**PLANNED UNIT DEVELOPMENT &  
SUBDIVISION STAFF REPORT****Date: May 15, 2003****DEVELOPMENT NAME** Heron Lakes Subdivision, Phase One,  
Resubdivision of Lot 61**SUBDIVISION NAME** Heron Lakes Subdivision, Phase One,  
Resubdivision of Lot 61**LOCATION** 1104 Heron Lakes Circle  
(West side of Heron Lakes Circle, 75'± South of  
Heron Lakes Drive)**PRESENT ZONING** R-1, Single-Family Residential**AREA OF PROPERTY** 1 Lot / .3± Acres**CONTEMPLATED USE** Detached single-family residential home with  
increased site coverage from 35% to 37%**TIME SCHEDULE  
FOR DEVELOPMENT** Immediately**ENGINEERING****COMMENTS** Must comply with all stormwater and flood control  
ordinances. Any work performed in the right of way will require a right of way permit.**TRAFFIC ENGINEERING****COMMENTS** Driveway number, sizes, location and design to be  
approved by Traffic Engineering and conform to AASHTO standards.**REMARKS** The applicant is requesting to amend an existing

APPLICATION NUMBER 6 & 7 DATE May 15, 2003  
APPLICANT Heron Lakes Subdivision, Phase One, Resubdivision of Lot 61  
REQUEST Subdivision and Planned Unit Development

# SITE PLAN

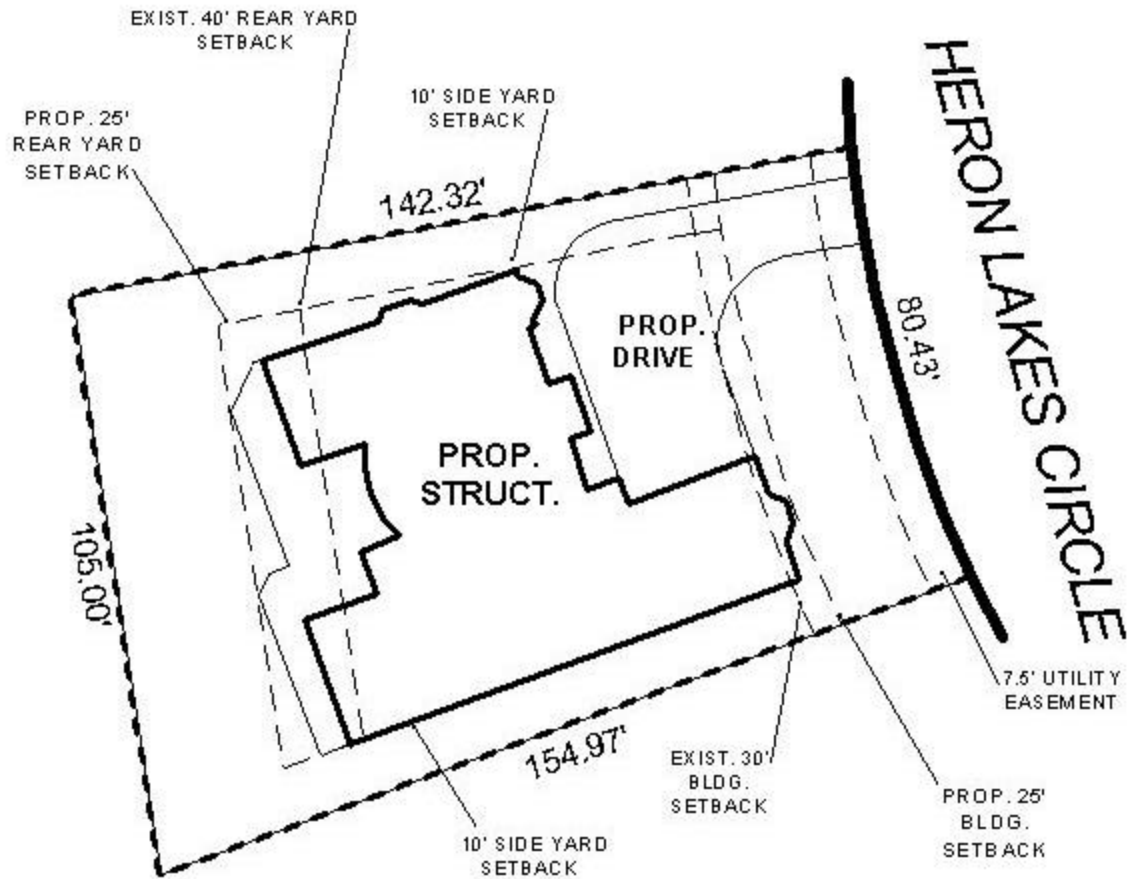
Planned Unit Development (PUD) approval to increase the maximum site coverage from  
35% to 37 percent for one lot. Additionally, on the record plat, 40-foot rear yard and 30-  
foot front yard setbacks were shown, and as the applicant proposes to reduce the rear and  
front yard setbacks to 25-feet, Subdivision approval is also required.

The proposed setback lines (25-feet on the front and rear) comply with the minimum setback requirements of both the Zoning Ordinance and Subdivision Regulations and thus could be considered appropriate for the site.

**Planned Unit Development:** Based upon the preceding, this application is recommended for approval.

**Subdivision:** The plat meets the minimum requirements of the Subdivision Regulations and is recommended for Tentative Approval.
